UNITED STATES PATENT AND TRADEMARK OFFICE

APPLICATION NO.	FILING DATE	FIRST NAMED INVENTOR	ATTORNEY DOCKET NO.	CONFIRMATION NO.
09/997,532	11/29/2001	SHAWN R. GETTEMY	PALM-3698	5478
7590 03/11/2004 WAGNER, MURABITO & HAO LLP Third Floor Two North Market Street San Jose, CA 95113			EXAMINER RAO, SHRINIVAS H	
			ART UNIT 2814	PAPER NUMBER

Office Action Summary

- 1) ☒ Responsive to communication(s) filed on 31 December 2003.
- 2a) ☒ This action is **FINAL**. 2b) ☐ This action is non-final.
- 3) ☐ Since this application is in condition for allowance except for formal matters, prosecution as to the merits is closed in accordance with the practice under *Ex parte Quayle*, 1935 C.D. 11, 453 O.G. 213.

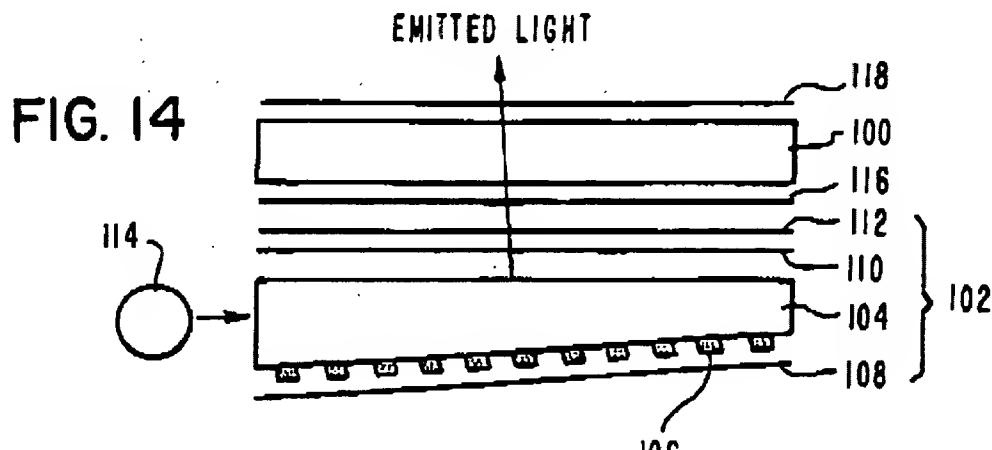
Applicants' next contention that Mamiya does not teach the recited light guide within the reflective display is not persuasive because fig. 14 reproduced below shows layer (which was equated to the reflective layer 104 and the reflective display as layer 108 in the outstanding rejection page 2 last 5-3 lines and not layer 116 has been alleged in the response) and in col. 6 lines 55 to 59 states :

the present invention. The back light shown in FIG. 5 is a back light where instead of the dotted pattern shown in FIG. 14 the light guiding sheet 1 of this embodiment has been attached to the back surface of the light guiding body 104 of FIG. 14 where the section is a wedge shape. And, a line-shaped light source 114 for example a cold cathode tube is

and as shown in figure 14 the top

surface of 104 is the reflective display (see below) :

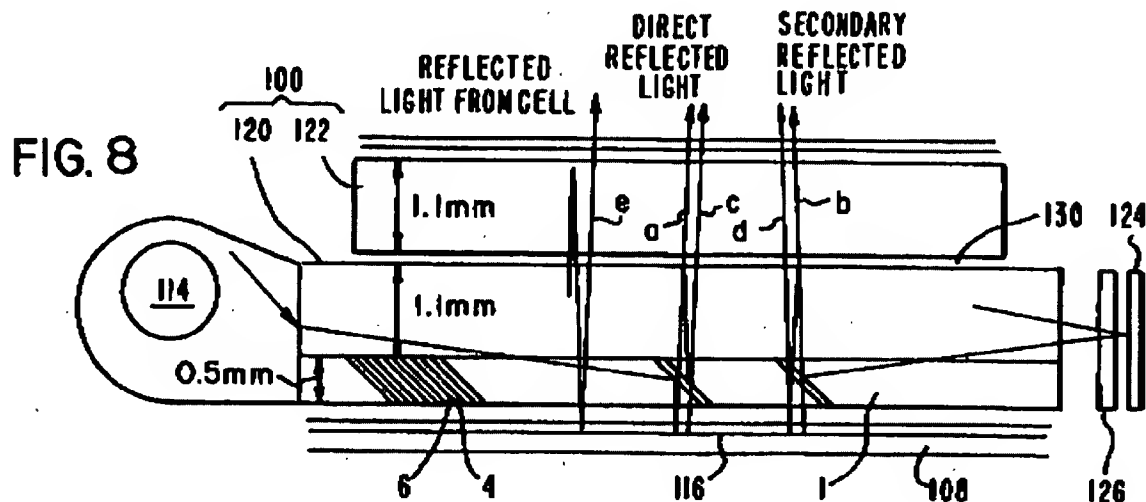
With respect to applicants' arguments regarding claims 2 and 13, Applicants' contend that polarizing plate layer 116 of figure 14 cannot be reasonable interpreted by

one skilled in the art as being comparable or interchangeable with a reflecting film. is not persuasive because the same layer 116 in figure 8 of Mimiya shows :

It is clear from the above that layer 116 (i.e . the polarizing plate layer) reflects at least several light elements marked a to e.

Applicants' next contention that Mimiya does not show " a front light reflecting film disposed above said top surface of said reflective display " is not persuasive because element 116 identified as (front light reflecting film and shown in the figure 8, etc.) is disposed above the top surface of the reflective display 102 in figure 14 which includes layer 104 (compared to the said reflective display) and its (104) top surface .
